UNITED STATES PATENT AND TRADEMARK OFFICE

10/606,123

Office Action Summary	Application No. 10/606,123	Applicant(s) SHINOHARA, TERUAKI	
	Examiner Mark A. Robinson	Art Unit 2872

DETAILED ACTION

Fig.1

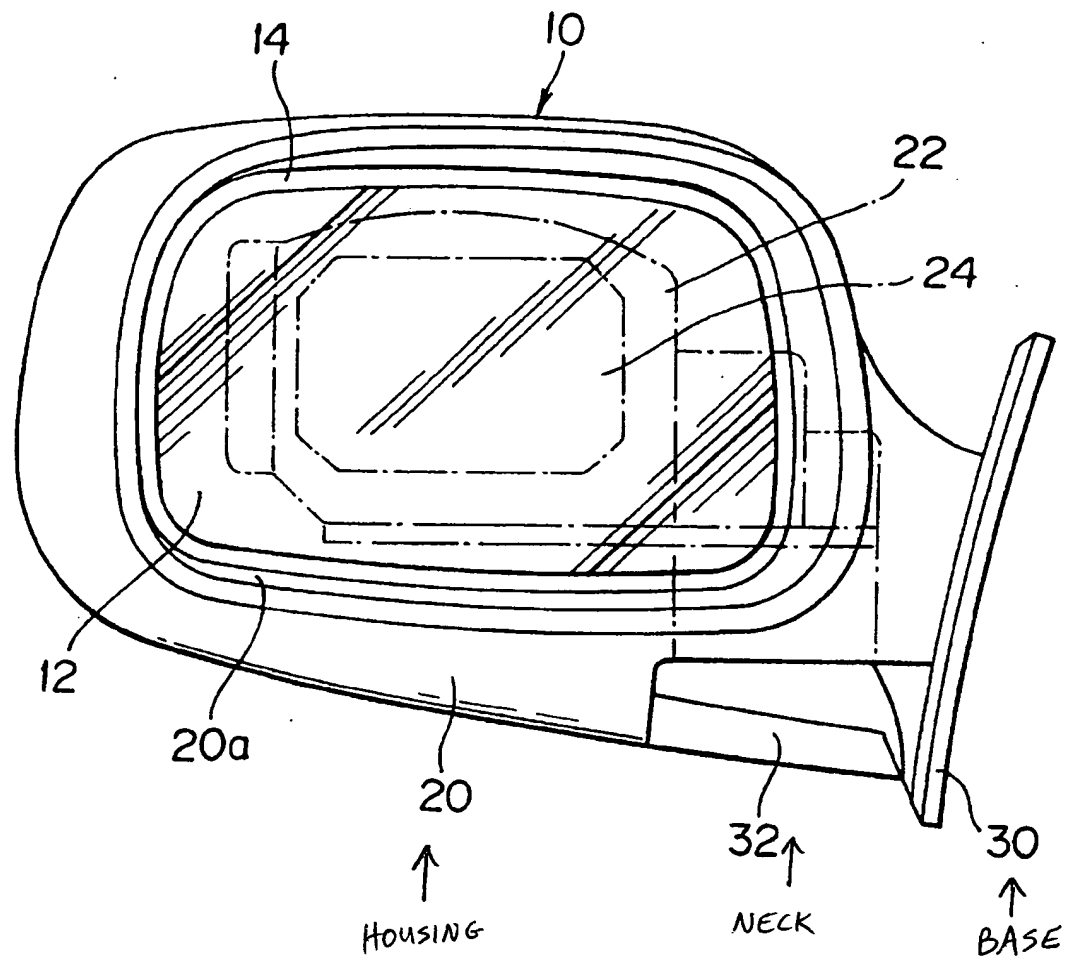
However, these portions together form a relatively narrow portion (i.e. a neck) between the housing 20 and the base 30. This neck is not required to be separate from either the housing

or the base as alleged in the remarks. Attached is an annotated copy of Iizuka fig. 1 and 3 showing the neck portion.

Fig. 3

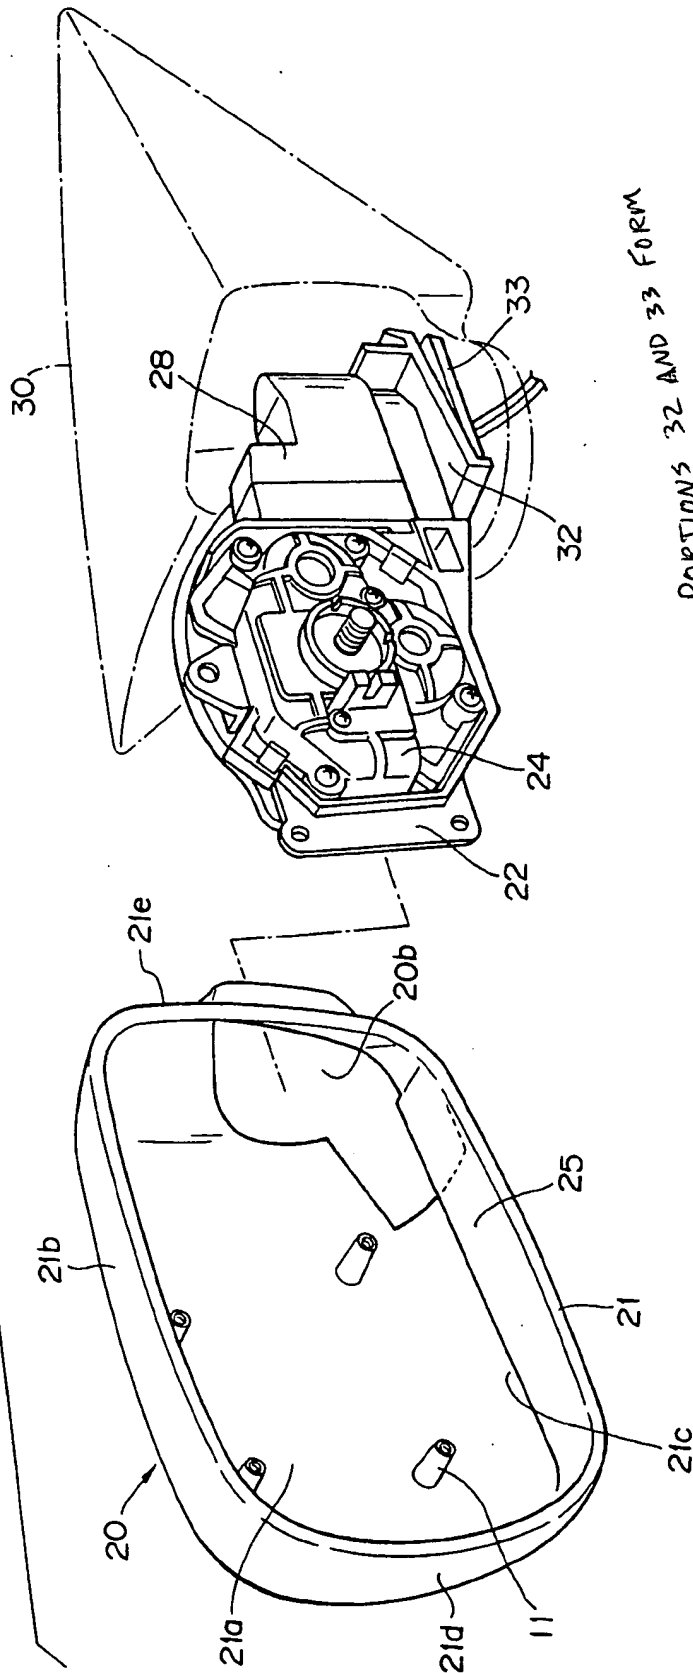
PORTIONS 32 AND 33 FORM
A "NECK" PORTION.
THIS PORTION IS BETWEEN
THE HOUSING AND THE BASE.
